International Aero Engines
SERVICE BULLETIN

**ENGINE - LP COMPRESSOR - INCORPORATION OF HIGH STRENGTH BOLTS
FOR ANNULUS FILLER ATTACHMENT**

V2500-A1

V2500-ENG-72-0362

Figure 1

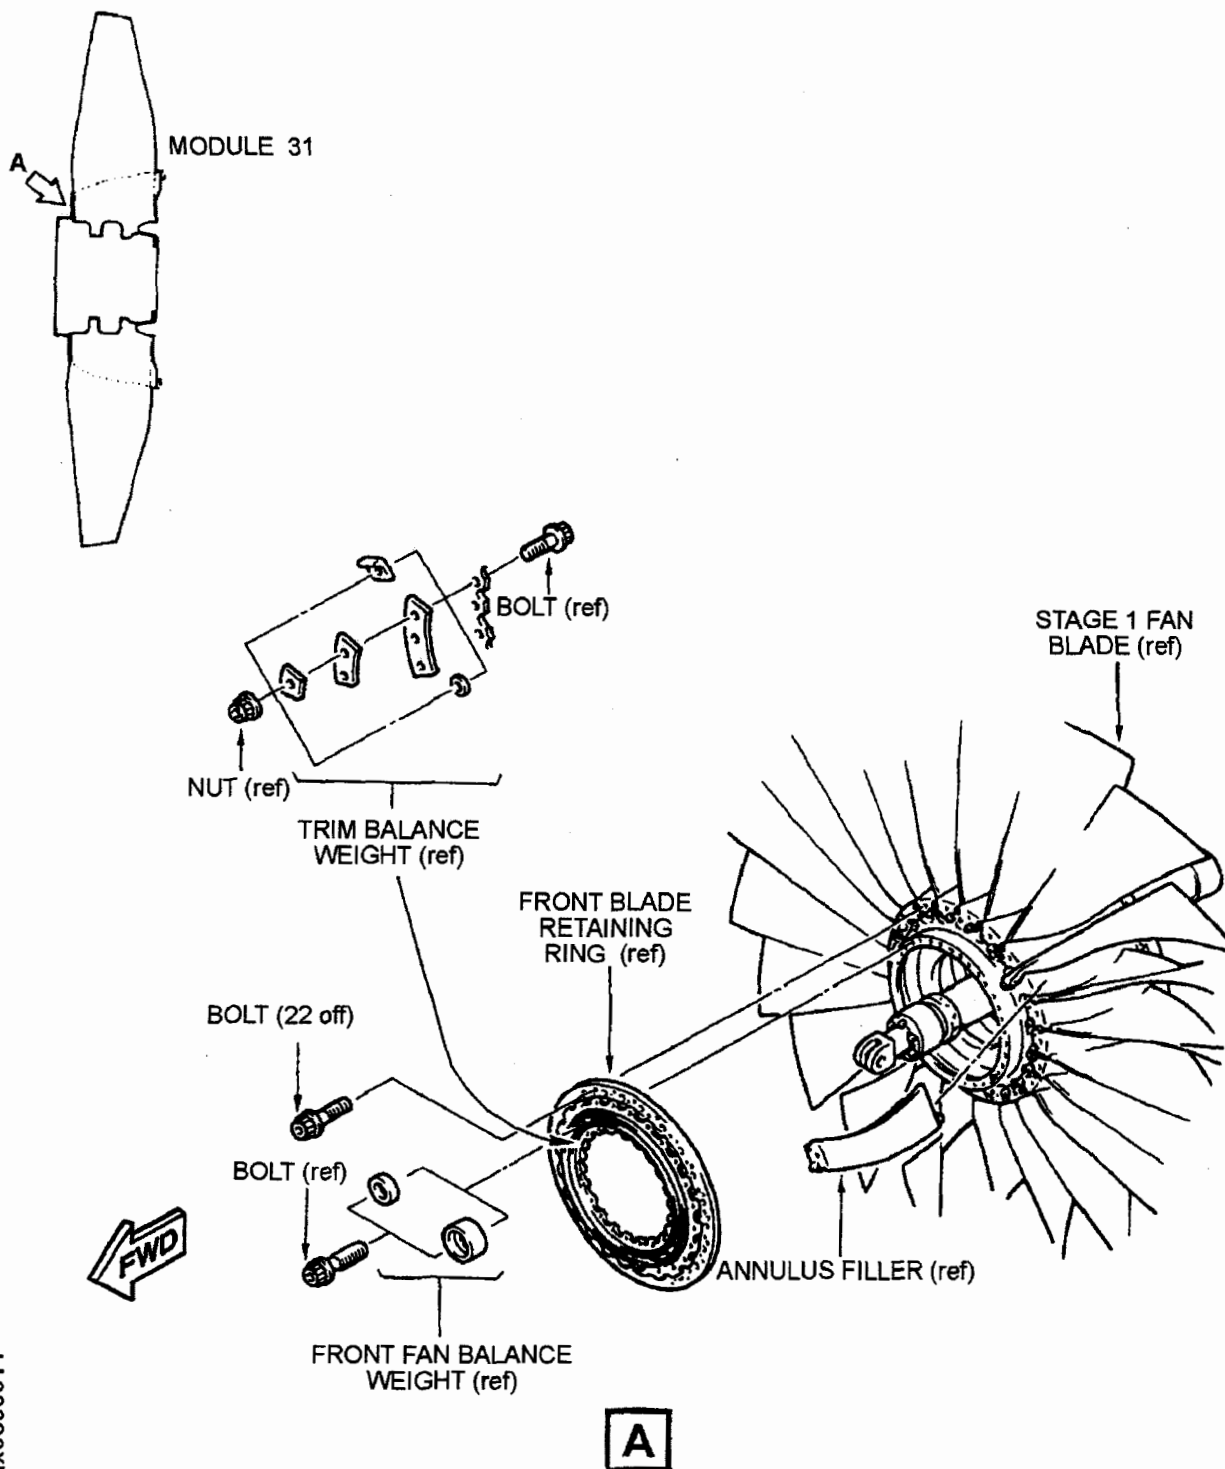
Location of the bolts that joint the front
blade retaining ring and the annulus filler

Replacement of the bolts which join the front
blade retaining ring and the annulus filler
Figure 2

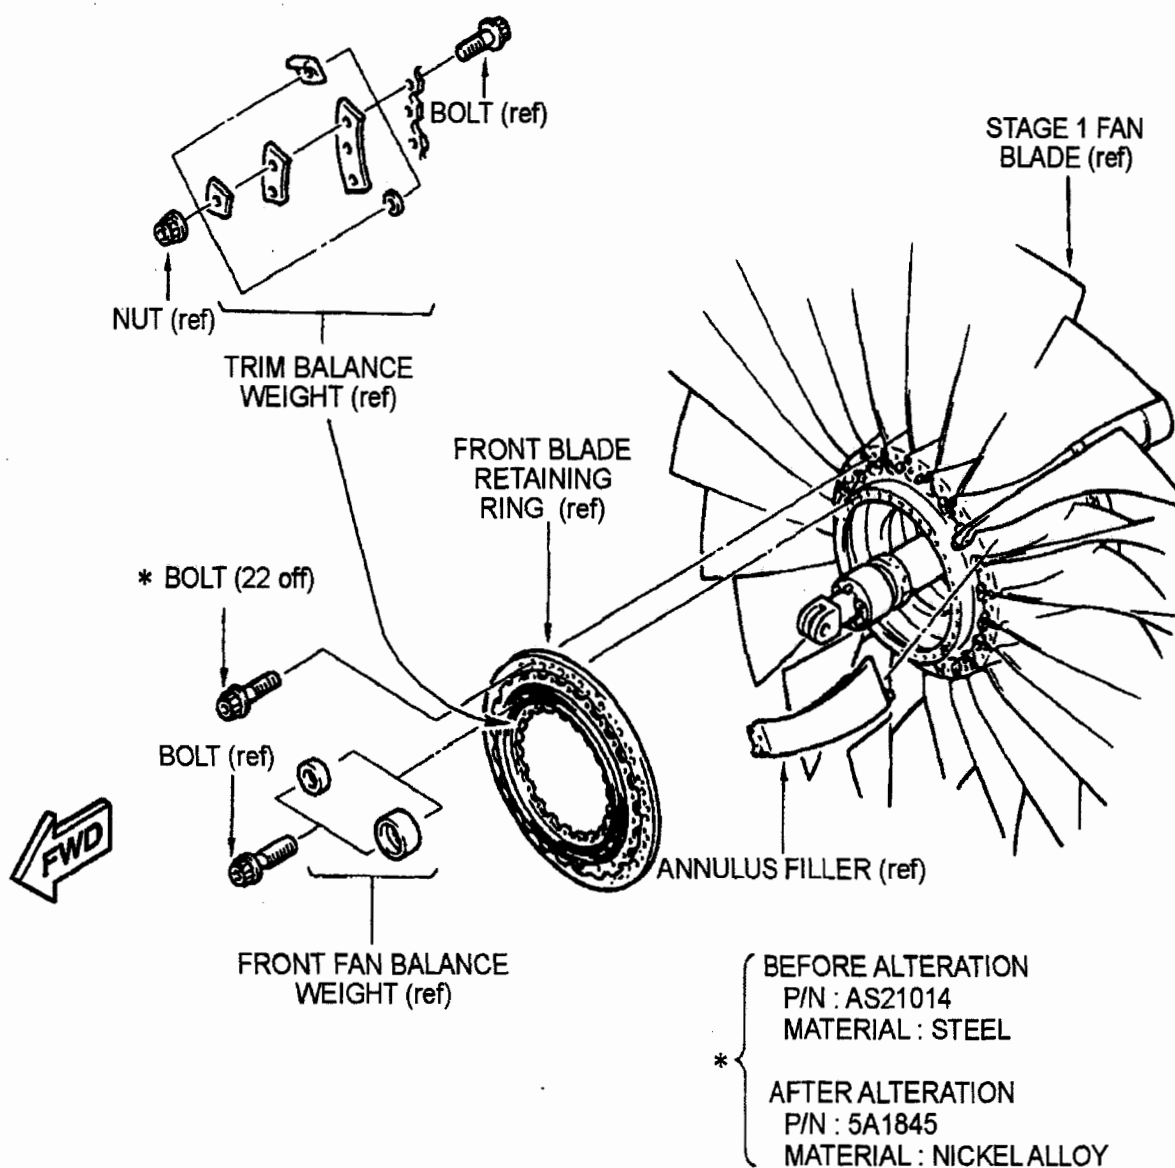
The material of the bolt which join the front blade retaining and the annulus fillers is changed from steel to nickel alloy. When the annulus filler trunnion fractures the filler will be retained by the attachment bolt. The LCF life of bolts made nickel alloy after the trunnion fracture are more than 900 Cycles.

- (1) Remove the existing bolts, (AS21014, 22 off) which secure the annulus fillers to the front blade retaining ring. For the correct procedures, refer to the Engine Manual (EM), Chapter/Section, 72-31-00, Disassembly.
- (2) Install the front blade retaining ring to the annulus fillers with the new bolts, (5A1845, 22 off). For the correct procedures, refer to the Engine Manual (EM), Chapter/Section, 72-31-00, Assembly.
